TSB # 10-2020

SUBJECT: Upgraded Frame Section Towers on XR750 and XR770 Harrow

FIX ON FAILURE (Failure Code 10.20)

Effective serial number range: XR Harrows prior to sn: 43684**-**

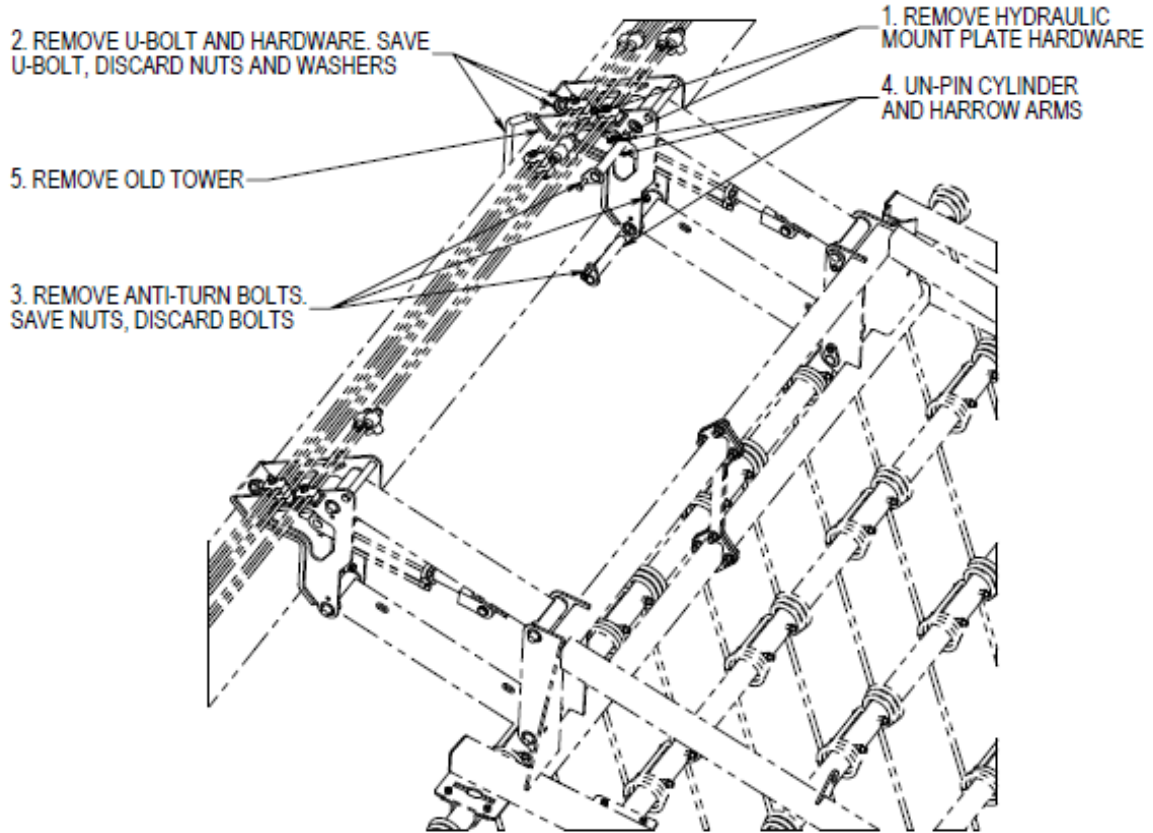
The existing version of the harrow section tower has been upgraded.

- A brace has been added to provide strength when the harrow sections are exposed to side-loading.
- A second mounting bolt has been added to provide better retention to the harrow beam and reduce the potential of mounting bolt failures.
- The side plates have been increased to ½" material eliminating the potential for cracking at the harrow arm pivot bolt mounting locations.

This new design is compatible with older units and an Upgrade Kit is available.

Part Number	Description	Dealer Cost	List Price
8622-98	Section Tower Upgrade Kit
